# Access Compliance Report

## Public Rights-of-Way

### (Curb Ramps)

Intersection ID: 7771	Main Street: SENIOR_DR	Cross Street: TWINFIELD_DR	Location: SW
ADA ID: 2BF349B82347	Ramp Type: Perp	Initial Pass/Fail: Fail	Overall Compliance: No
		Severity Score: 17.5

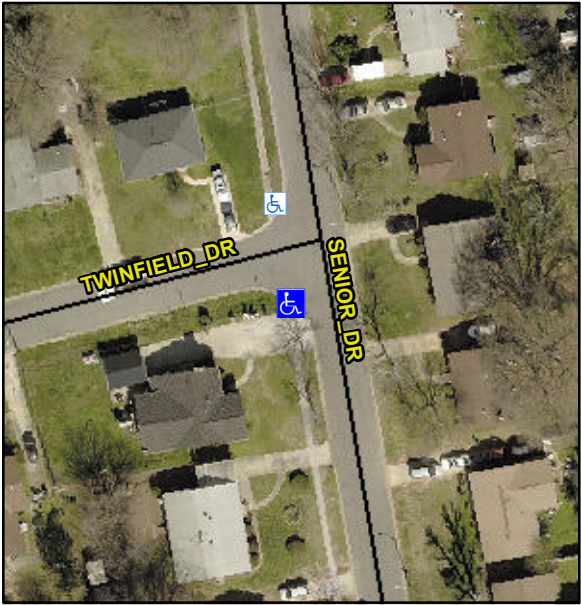
Codes/Mitigation Info/Possible Solution			Field Measurements/Component Compliance		
	Possible Solutions:		<b>Compliance</b>	<b>Description</b>	<b>Data</b>
	Remove & Replace Entire Ramp.		N/A	Ramp Length (in)	55.5
			No	Ramp Width (in)	35.5
			N/A	Flare Type LT	N/A
			N/A	Flare Slope LT (%)	N/A
			N/A	Flare Traversable LT?	N/A
			N/A	Landing Length (in)	N/A
			N/A	Landing Width (in)	N/A
			N/A	Landing Slope (%)	N/A
			N/A	Landing X Slope (%)	N/A
<p>Surveyor Notes:</p> <p>N/A</p> <p>PROW/ADA:</p> <p>R304.5.1</p>			N/A	Flare Type RT	N/A
			N/A	Flare Slope RT (%)	N/A
			N/A	Flare Traversable RT?	N/A
			N/A	DWS Provided?	N/A
			N/A	DWS Contrast?	N/A
			N/A	DWS Length (in)	N/A
			N/A	DWS Full Width?	N/A
			N/A	DWS Offset (in)	N/A
			N/A	Gutter Ponding?	N/A
			N/A	Gutter Lip Ht (in)	N/A
			N/A	Painted X Walk1?	No
				X Walk 1 Direction	To N
			N/A	X Walk 1 Width (in)	N/A
				X Walk 1 Slope (%)	0.8
				X Walk 1 X Slope (%)	1.8

N/A	Ramp inside XWalk1?	N/A
				Road Slope (%)	N/A
				Road X Slope (%)	N/A
			N/A	Any Obstructions?	N/A
				Obstruction Type	
Total Cost:			\$	1850.00	
					N/A
				Yes	Surface Condition? (G/P)
					Good
